CITY OF SEASIDE
BOARD OF ARCHITECTURAL
REVIEW

SPECIAL MEETING
Council Chamber
440 Harcourt Avenue
Wednesday, July 10, 2019
4:00 PM

- A. BOARD OF ARCHITECTURAL REVIEW APPROVAL (FILE No. BAR-19-07) MARC AND JEANETTE DRANCHAK, PROPERTY OWNER, AND ALLEN ROBINSON, APPLICANT, ARE REQUESTING DESIGN REVIEW APPROVAL FOR A ROOFTOP DECK ADDITION TO AN EXISTING ONE-STORY SINGLE FAMILY DWELLING LOCATED AT 1892 JUAREZ STREET IN THE RS-12 (SINGLE FAMILY RESIDENTIAL) ZONING DISTRICT (APN: 012-015-039). THIS PROJECT IS CATEGORICALLY EXEMPT CLASS 1, SECTION 15301.E.1, EXISTING FACILITIES, FROM THE CALIFORNIA ENVIRONMENTAL QUALITY ACT. CONTINUED FROM THE JUNE 5, 2019 MEETING.**

- B. BOARD OF ARCHITECTURAL REVIEW APPLICATION NO. BAR-19-07. CLAY AND LISA MATTHEWS, PROPERTY OWNERS, AND THOMAS RETTENWENDER, APPLICANT, ARE REQUESTING DESIGN REVIEW APPROVAL FOR A 478 SQUARE FOOT ROOF DECK ABOVE A NEW TWO CAR GARAGE ATTACHED TO A ONE STORY SINGLE FAMILY DWELLING LOCATED AT 1565 ORD GROVE AVENUE IN THE RS-8 (SINGLE FAMILY RESIDENTIAL) ZONING DISTRICT (APN 011-043-014). THE PROJECT IS CATEGORICALLY EXEMPT CLASS 1, SECTION 15301(E)(1) FROM THE CALIFORNIA ENVIRONMENTAL QUALITY ACT. CONTINUED FROM THE JUNE 19

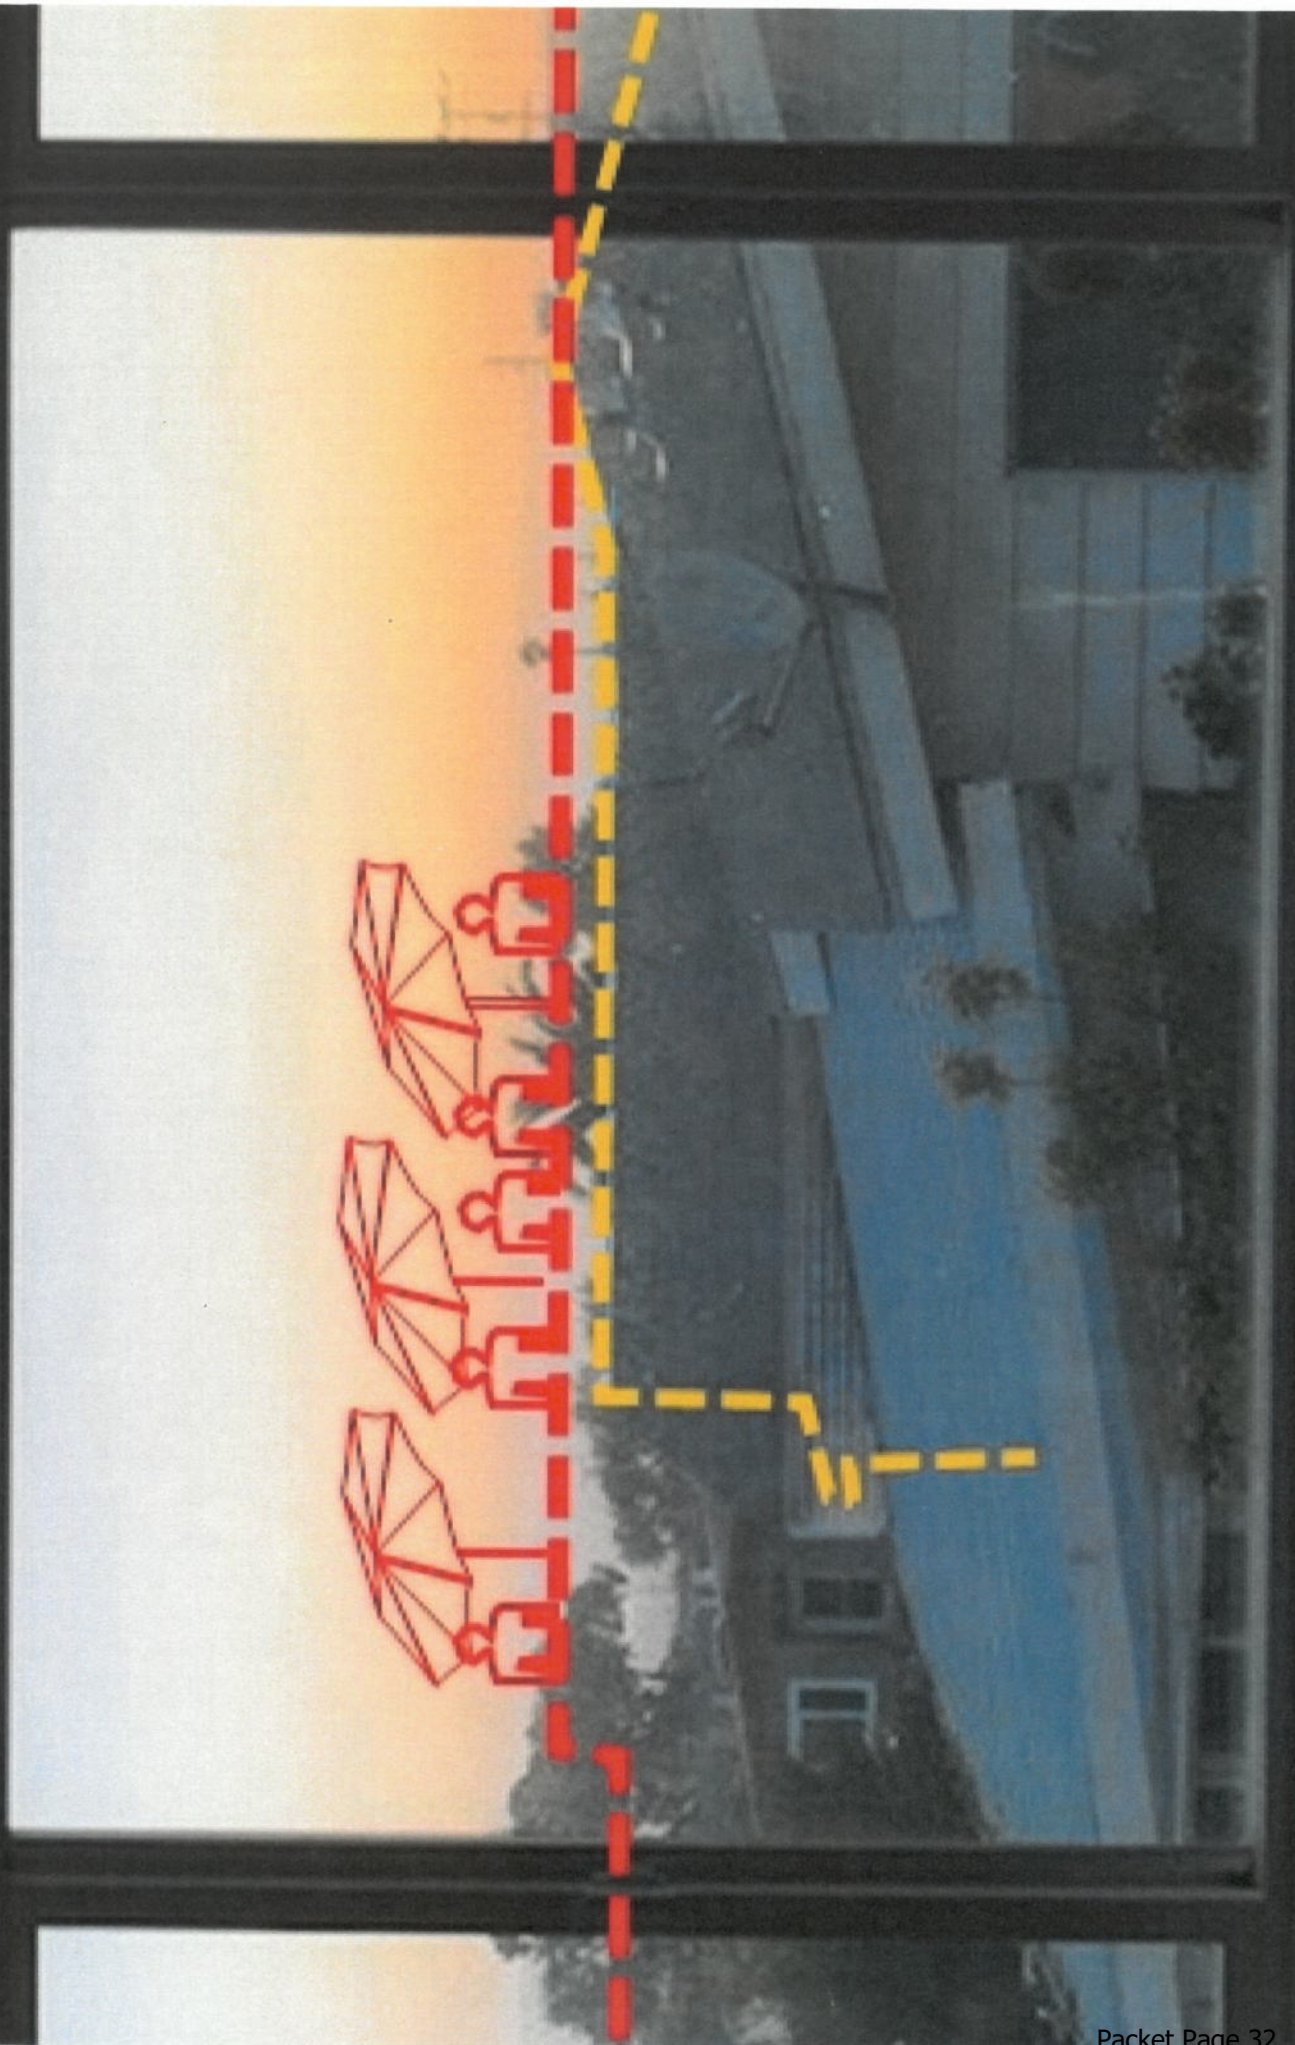
I'm also disappointed that the Commission did not "stake & flag" the proposed construction to satisfy "Goal UD-3" and "Policy UD-3.1", as stated in the Community Development Mgr's Report dated April 24, 2019. As you can see in the "photo-drawing", it definitely obstructs our view.

Existing West Elevation (Juare

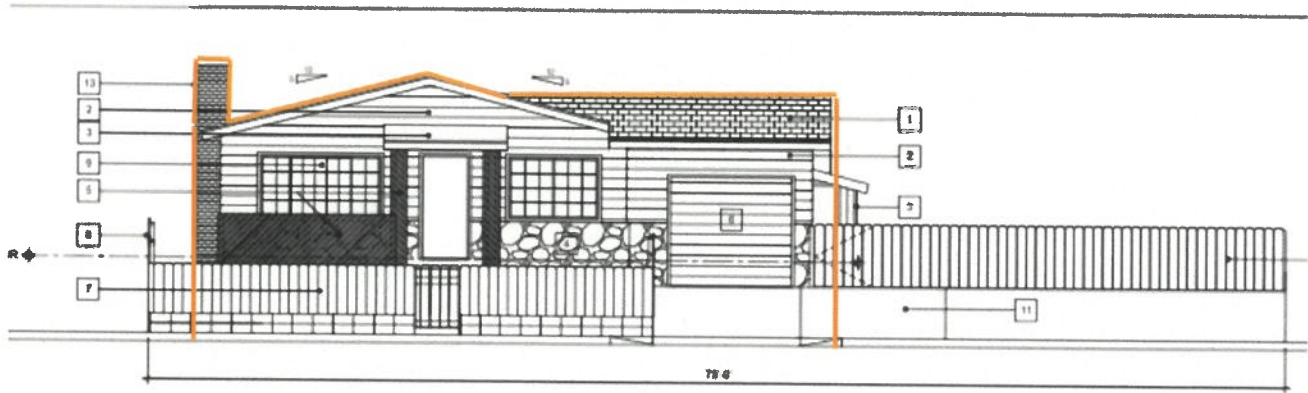
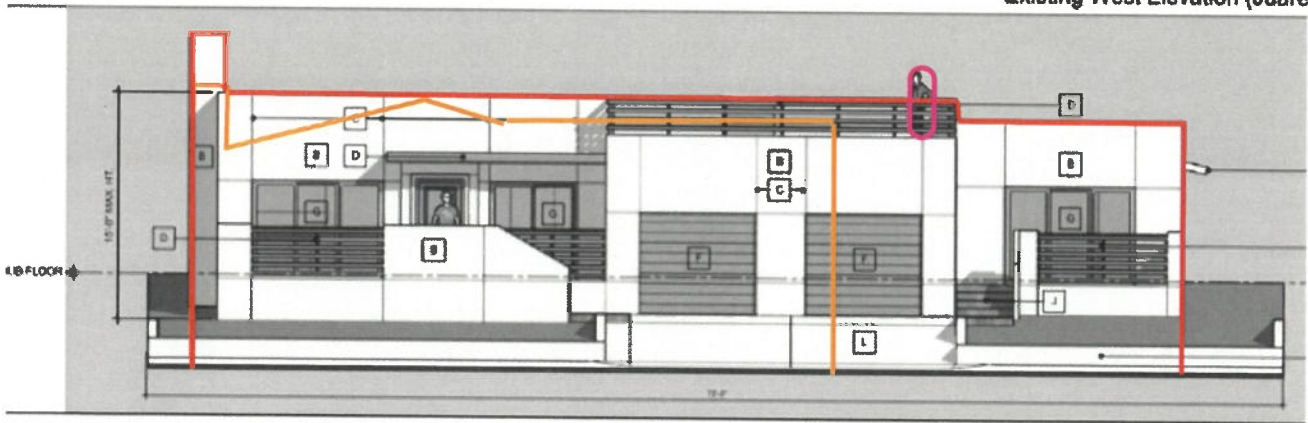
So, we've been burdened with providing this evidence to you ourselves, in addition to the written objection my mother previously submitted. As you can see from the pictures provided, a deck would obstruct our view of the Monterey Bay, which is a clear violation of Policy UD-3.1 of the Seaside General Plan.

Policy UD-3.1 protects private views of significant natural features, such as the Monterey Bay, Roberts Lake, the Pacific Ocean, the surrounding mountains, and other important viewsheds. The part of the ocean that is visible from our house, and other important viewsheds as outlined in Policy UD-3.1, add a lot of value to our property. To build this deck would devalue our home significantly.

Additionally, no one builds a deck without putting some sort of furniture or other items on top. These added features not only threaten our view even more, but also our privacy. Whether our homes meet some minimum requirement for distance from each other or not, the reality is that if a deck is built, anyone standing on it would have a direct view into our den and into our master bedroom.
